### **Subdivision**

Recommendation

*A DC Property Quest map detail provides a sense of the varied, but often crowded spacing of historic buildings in the vicinity.*

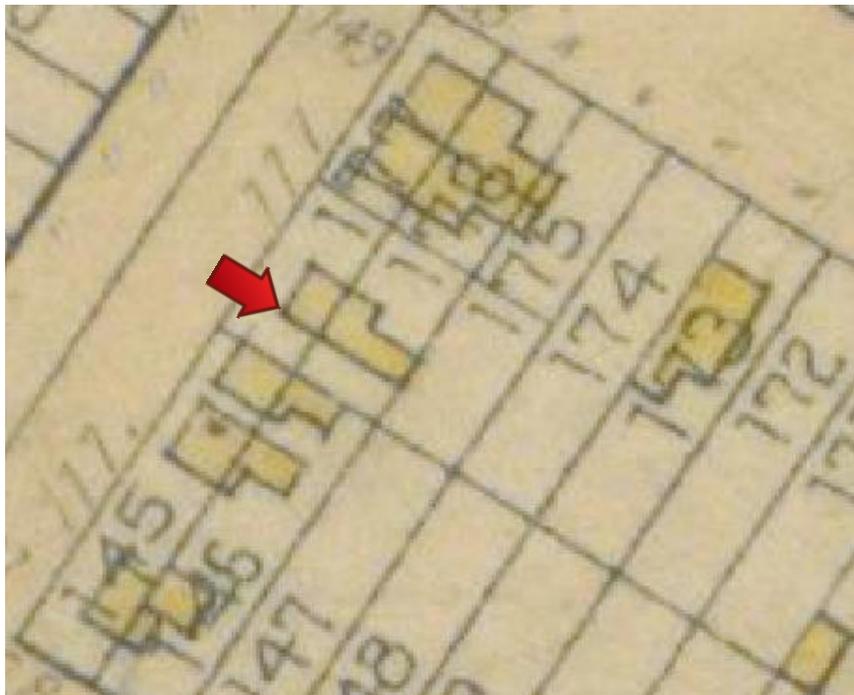
The property's immediate context offers numerous examples of closely spaced and even semidetached and row homes, including those immediately to the east, west, down the block and around the corner. The original Uniontown subdivision into mostly 28-wide lots is not inconsistent with the pattern that developed on this square, but old maps are not too instructive for suggesting what should be the extent of this particular lot, which was developed perpendicularly across the originally platted lot lines (see 1887 Hopkins map detail below). Clearly, close spacing, a rapid but varied "rhythm" is not, in itself, incompatible. But does the

occupation of the side yard too adversely affect the setting of the historic subject house? Yes and no.
